From: Simon Davis
Sent: 21 October 2020 15:55
To: 'Natalie McKellar' [REDACTED]
Cc: Kerry Simmons [REDACTED]
Subject: RE: Springfield, Hook Lane - AL/64/20/PL

Further to the email below and our ongoing discussions regarding the protection of trees at Springfield I attach an updated Arboricultural Impact Assessment & Method Statement to accompany the application. This has been updated as per Mark's comments in terms of the drainage channel to the north-eastern corner of the site.

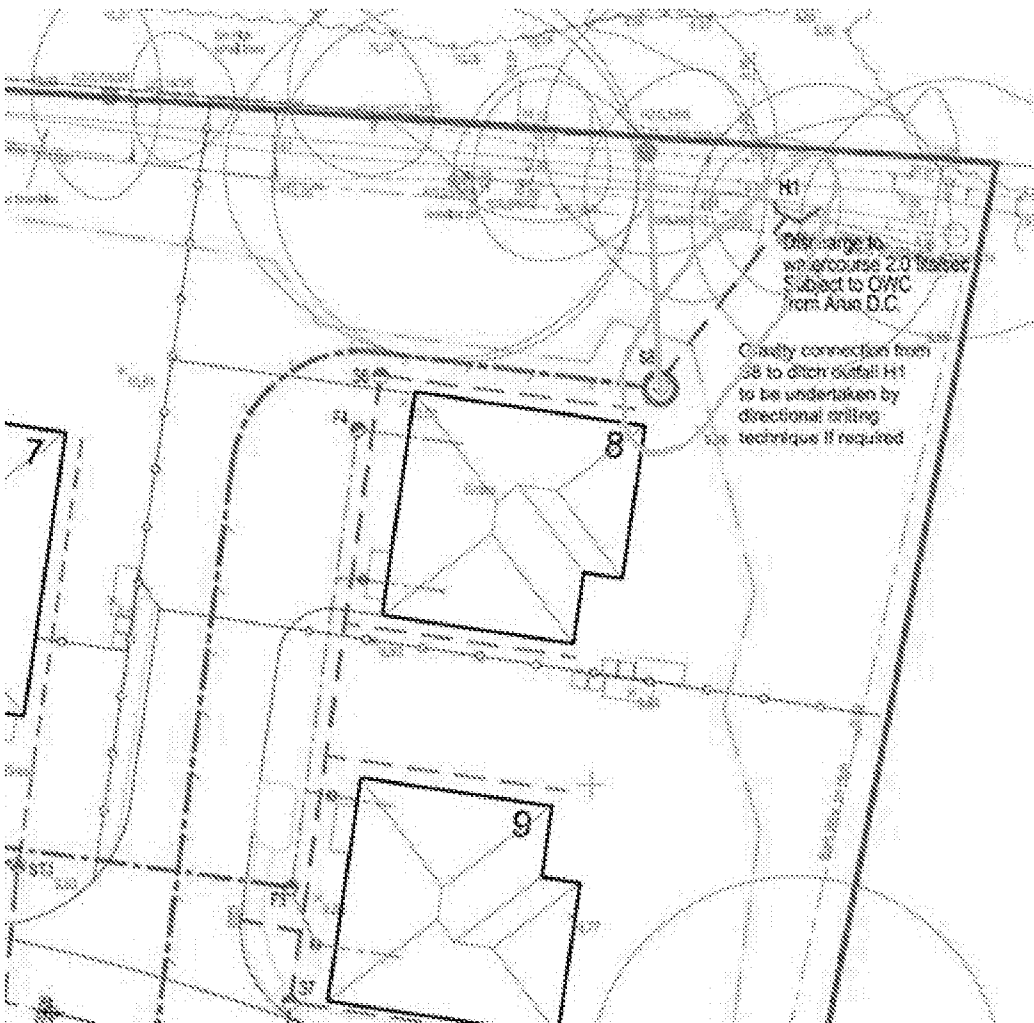
The Engineering Details Drainage Strategy for the site as illustrated (dwg. no. 602-01, Rev C) is broadly respectful of retained trees and their growth potential, with the obvious exception being chosen route of surface water discharge to the north boundary watercourse and construction of headwall – both within the RPA of retained (off-site?) mature Cypress T21. Directional drilling technique is proposed 'if required'. I say it is necessary unless exploratory excavation findings permit standard trenching. All that to be set out in the required Arboricultural (Impact Assessment &) Method Statement. ***Might it not be easier to take a more northerly route from manhole S8 and avoid significant tree's (T18 & T21) RPA altogether,*** subject to suitable ground levels (gravity connection)?

I have highlighted the relevant part regarding the suggested re-routing of the drainage run as whilst we appreciate the drainage is currently shown heading north-east from manhole S8 and would be within the edge of the RPZ of T21 (circled in orange) if we move the drainage run to a more northerly position from S8 (orange arrow) as suggested this would encroach more within the RPZ of T18, which I believe is a Category B tree (T21 being a C category tree). We are keen to work with you to make revisions and at present the drainage scheme is only indicative however we want to make sure any changes address Mark's concerns in order to present the application with the best chance of success before Committee. As such we would be grateful for any comments you may have in this regard.

I have spoken with Mark and he suggests either of two things:

- (1) You amend the Method Statement to make it implicit that exploratory excavation will be carried out and if roots are present along the drainage channel line then directional drilling to take place; or
- (2) You take a new drainage run in a northerly direction (not quite straight north) and aim to bisect the RPAs of onsite T18 and offsite T21.
